How to update T32MZ

T32MZ SOFTWARE UPDATE CHANGES**(Editor Version: 3.7 Encoder version: 1.3)**

◆ S.BUS Basic screen

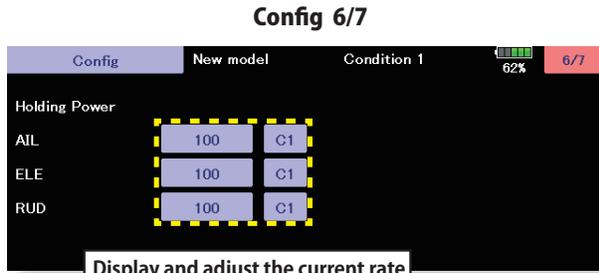
The second page has been added, and the total number of pages has changed from 2 to 3.

Additional page

Tap to move to the rate switching CH setting page.

Holding Power C2 to C5

Tap the CH used for rate switching to select it.

The current rate numbers C1 to C5 are displayed by operating the channel of the transmitter.

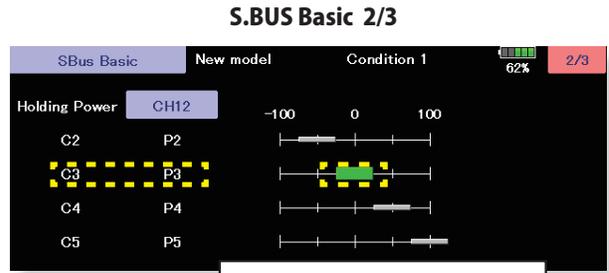
Display and adjust the current rate numbers C1 to C5 by operating the channel on the transmitter.

By operating the channel of the transmitter, the channel position of the current rate numbers C1 to C5 will be displayed in green.

◆ The registered ESC will be displayed as "Futaba ESC".

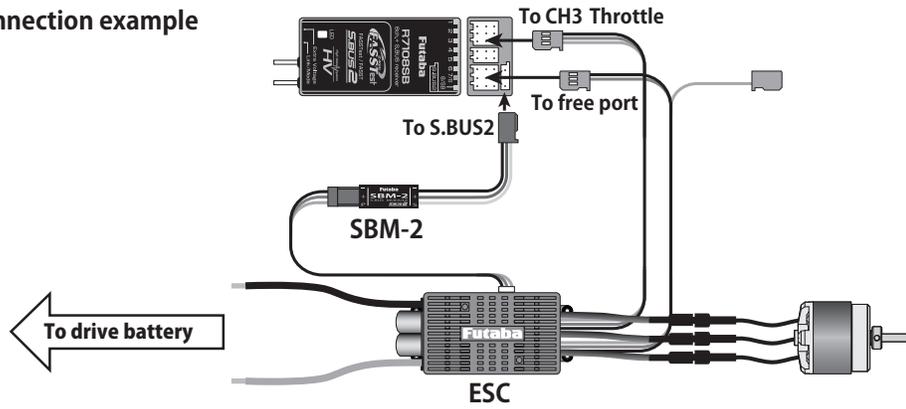
Connect the SBM-2 to the S.I / F port on the back of the transmitter.

1. Connect the **SBM-2** to the **S.I/F** port in the rear of the transmitter.
2. Open the sensor unit setting screen by touching the **[Sensor]** button in the Linkage Menu.
3. Touch the 1/2 to enter the second page of the Sensor screen. Then, touch the **[Register]** button.
4. If registration is successful, the following screen will appear. **"The registering succeeded."** Close the message by touching the [Close] button.
5. If registration failed, a screen like the following will appear:

Tap register

2. Add R.P.M. display : Gov Basic

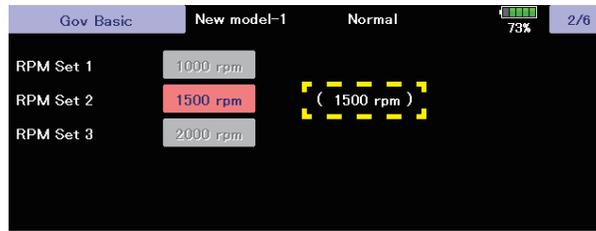
The number of revolutions of the governor setting is displayed on the governor basic screen of the gyro setting.

3. GYA553 Addition of setting parameters

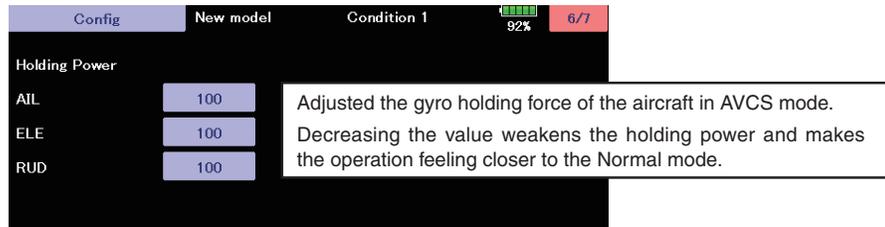
AIL / ELE / RUD holding power setting has been added to the setting parameters of GYA553.

1. Add Screen off function [Quick start]

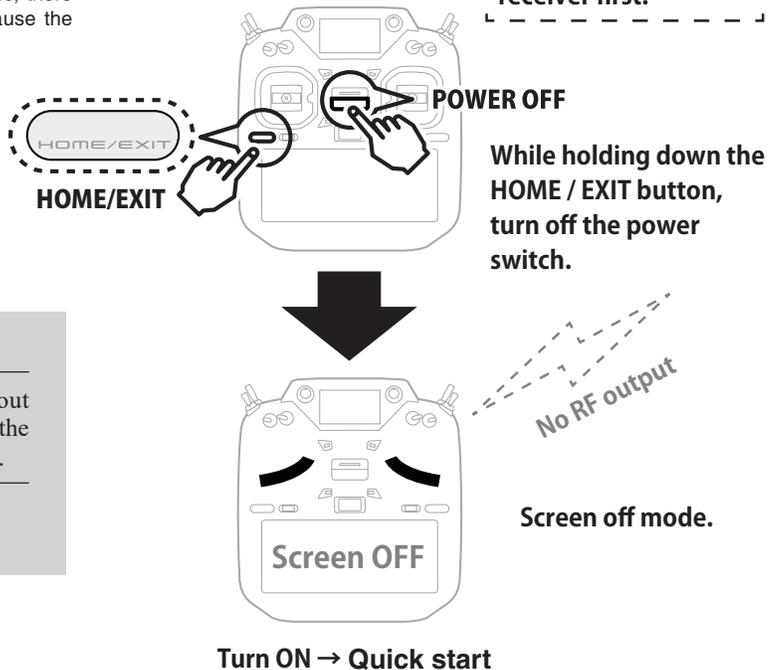
This "screen off" can quick start next startup. This is convenient when turning on and off frequently. No RF output at "screen off". Also, there is no screen display. However, the battery is consumed because the internal circuit is activated.
